Access Compliance Report

Public Rights-of-Way

Intersection ID: 29980	Main Street: LONG_HILL_DR	Cross Street: WINDING_RIVER_DR	Location: NW
ADA ID: 32E745FC46F4	Ramp Type: BlendTrans1	Initial Pass/Fail: Fail	Overall Compliance: No
		Severity Score: 8.75

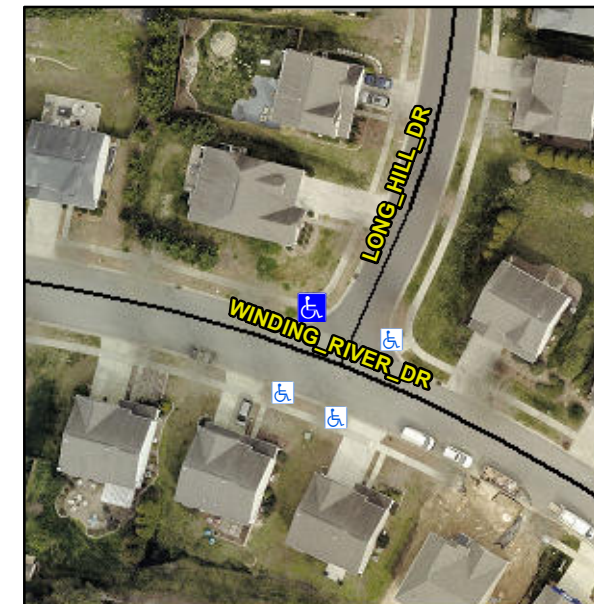
Remove & Replace Curb Ramp With Two New Directional Ramps or Equivalent.

R304.5.1

Compliance	Description	Data	Compliance	Description	Data
N/A	Ramp Length (in)	73.0	Yes	BlendTrans Slope (%)	4.2
No	Ramp Width (in)	47.5	Yes	BlendTrans XSlope (%)	1.3
N/A	Flare Type LT	N/A	N/A	Flare Type RT	N/A
N/A	Flare Slope LT (%)	N/A	N/A	Flare Slope RT (%)	N/A
N/A	Flare Traversable LT?	N/A	N/A	Flare Traversable RT?	N/A
N/A	Landing Length (in)	N/A	N/A	DWS Provided?	N/A
N/A	Landing Width (in)	N/A	N/A	DWS Contrast?	N/A
N/A	Landing Slope (%)	N/A	N/A	DWS Length (in)	N/A
N/A	Landing X Slope (%)	N/A	N/A	DWS Full Width?	N/A
N/A	Landing Curb? (Y/N)	N/A	N/A	DWS Offset (in)	N/A
N/A	Shared Landing?	N/A			
N/A	Gutter Ponding?	N/A	N/A	Gutter Slope (%)	N/A
N/A	Gutter Lip Ht (in)	N/A	N/A	Gutter X Slope (%)	N/A
N/A	Painted X Walk1?	No	N/A	Painted X Walk2?	No
	X Walk 1 Direction	To S		X Walk 2 Direction	To SE
	X Walk 1 Width (in)	N/A		X Walk 2 Width (in)	N/A
	X Walk 1 Slope (%)	1.3		X Walk 2 Slope (%)	3.2
	X Walk 1 X Slope (%)	3.5		X Walk 2 X Slope (%)	4.4
